**RE: Planning application 2019/1697/P for works at rear of 29 & 33 Arkwright Road London NW3 Proposal: Construction of 2no. detached, two storey dwelling houses (1x 2bed, 1x 3bed; Use Class C3), replacement boundary wall to lane and associated site re-landscaping.**

**Discussion on trees at the proposed development site:  
29-33 Arkwright Road London NW3 6BJ**

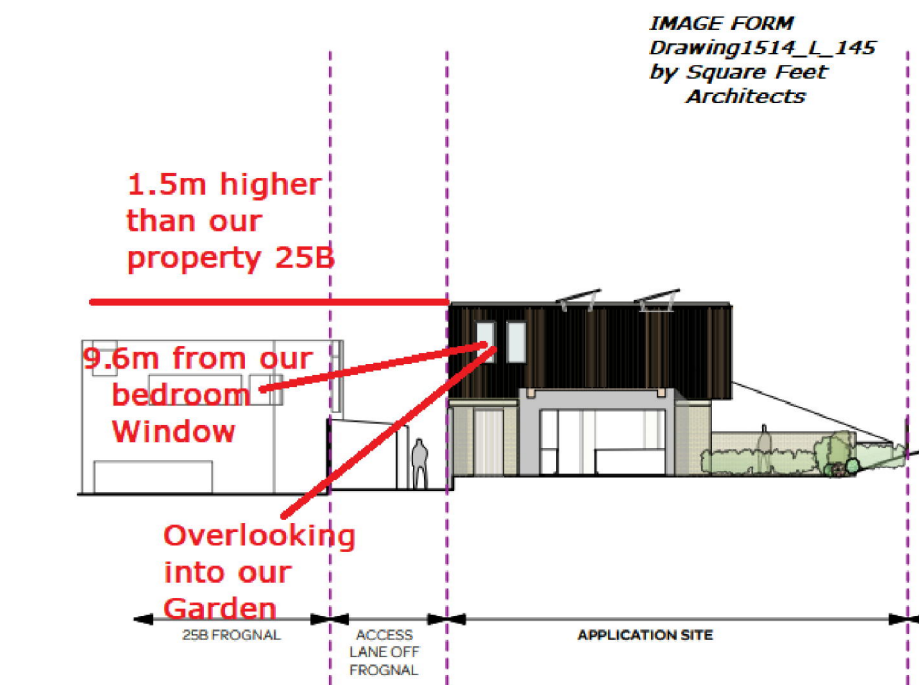
The character of the driveway entrance to the laneway is dominated by the stunning tree's ahead in the Photograph below. The loss of the Tree's will have a severe visual impact on the laneway. We would like to bring your attention to Policies RF35, RF36 and RF37 of the Redington/Froggnal conservation area statement 20 which protects tree's in this conservation area and are being ignored.

*Illustrative view from the garden of 25B Frognal looking north towards the proposed development.  
The image clearly demonstrates a sense of enclosure and an intrusion of privacy at 25B Frognal.*

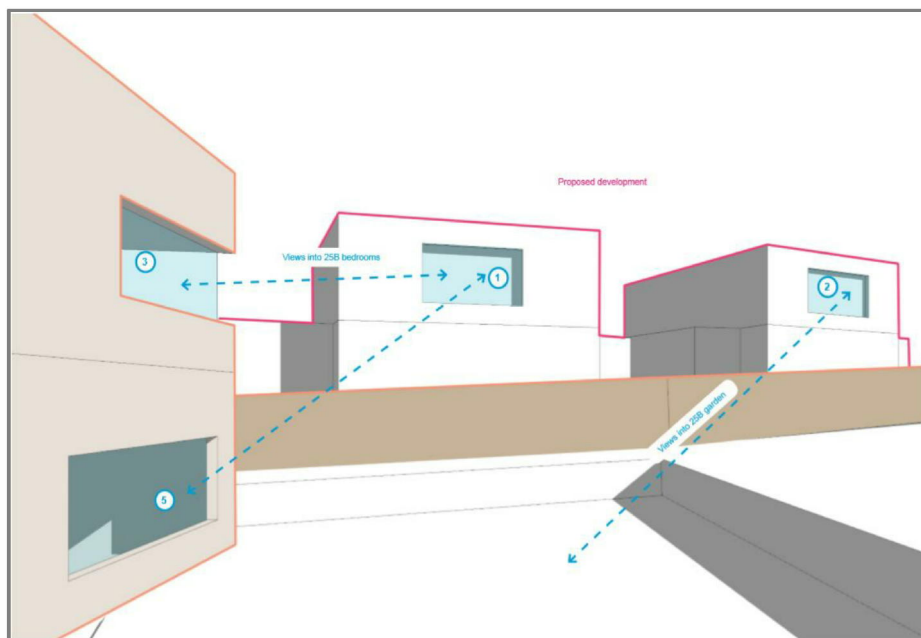
The Council's policy D1 states good design should ensure buildings do not significantly overshadow existing/proposed outdoor spaces (especially designated open spaces) and amenity areas. In addition to this, the policy states to consider the extent to which developments may overlook the windows or private gardens of other dwellings. With regards to promoting good design, the policy states: *"development should be designed to protect the privacy of both new and existing dwellings to a reasonable degree. Spaces that are overlooked lack privacy. Therefore, new buildings should be carefully designed to avoid overlooking, with the most sensitive areas being Bedrooms; Kitchens; Living rooms; and the part of a garden nearest to the house".*

*Due to the topography of the surrounding site, two storey developments appear to be nearly three storeys from 25B*

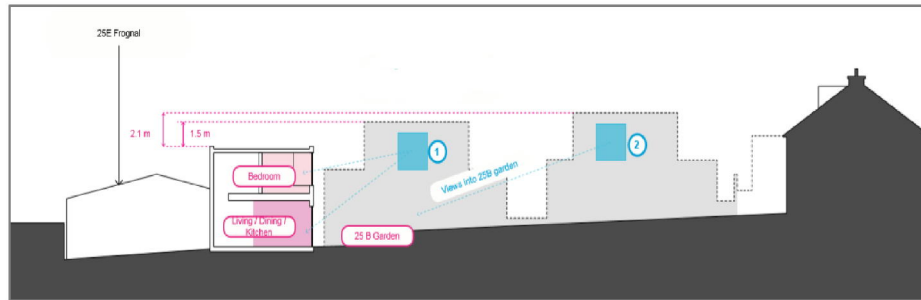
To ensure privacy, the council states it is good practice to provide a minimum distance of 18m between the windows of habitable rooms in existing properties directly facing the proposed (either residential or non-residential) development, assuming a level topography. In instances where building heights, design or topography mean that opportunity for overlooking would be increased, it is advisable to increase this separation distance. The 18m should be measured between the two closest points on each building. The plan below, clearly demonstrates that at its closest point, the proposed development will be within a 9.5m distance from my property. This proximity is clearly unacceptable as the sense of enclosure will be overbearing and oppressive.

The plans submitted with this application, fail to acknowledge the bedroom windows on the first floor of my property and therefore do not mitigate this sense of enclosure, with the proposed development situated just meters away from this habitable space. I am concerned this application has not been designed appropriately on privacy or overlooking grounds. The above image demonstrates the close proximity to my property. The overlooking and or perceived effect of overlooking is not acceptable.
